# DEVELOPMENT APPLICATION EVALUATION REPORT

Doc No. #A2018/40399

<b>Panel Reference</b>	2019NTH015
<b>DA Number</b>	10.2018.650.1
<b>LGA</b>	Byron Shire Council
<b>Proposed Development</b>	Demolition of existing building and construction of a mixed use development - Tourist and Visitor Accommodation (Hotel 146 Rooms), Function Centre and Food and Drink Premises
<b>Street Address</b>	98-106 Jonson Street, Byron Bay
	Proposed Lot 42 and Part Proposed Lot 41 in the subdivision of Lots 6 & 7 DP 619224 and Lots 8 & 9 DP 617509
<b>Applicant/Owner</b>	Applicant: Mercato on Byron Pty Ltd c/- Urbis Pty Ltd Owner: Task Group Services Pty Ltd as trustees for The Group Services Trust and Wingate Byron Property Holdings Pty Ltd as trustee for The Wingate Property Trust
<b>Date of DA lodgement</b>	19 December 2018
<b>Number of Submissions</b>	423 all opposing the proposed development
<b>Recommendation</b>	Pursuant to Section 4.16 of the Environmental Planning & Assessment Act 1979, it is recommended that development application no. 10.2018.650.1 for Mixed Use Development for Tourist and Visitor Accommodation (Hotel 146 Rooms), Function Centre and Food and Drink Premises, be <b><u>refused</u></

*Photo 1: Trees on the right to be removed; trees on the left to be retained, subject to access design*

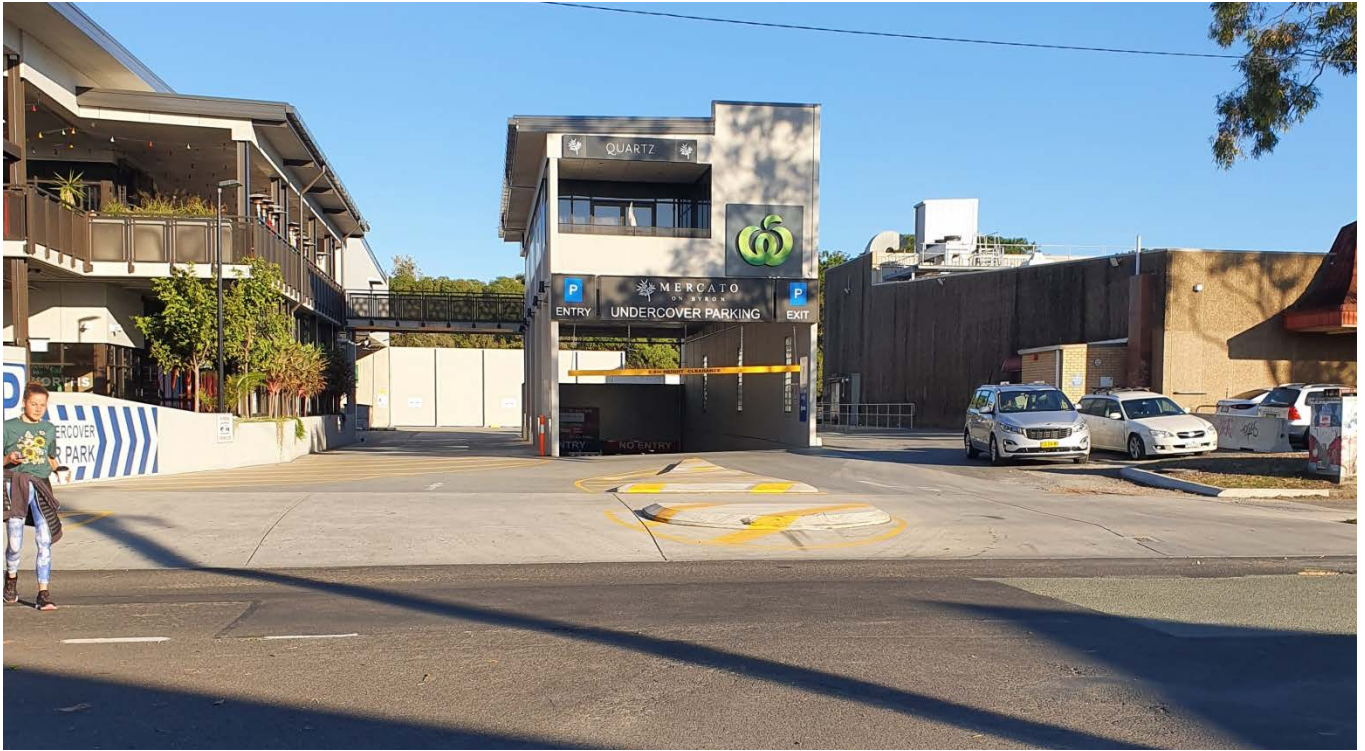
Vegetation within the property will be removed, but trees within the Jonson Street footpath are proposed to be retained. It is noted, however, that the width of the driveway access to the basement access is proposed at 3.6m, which does not comply with the relevant Australian Standard. Compliance with that standard has the potential to require the removal of at least one of the existing street trees within the Jonson Street road reserve.
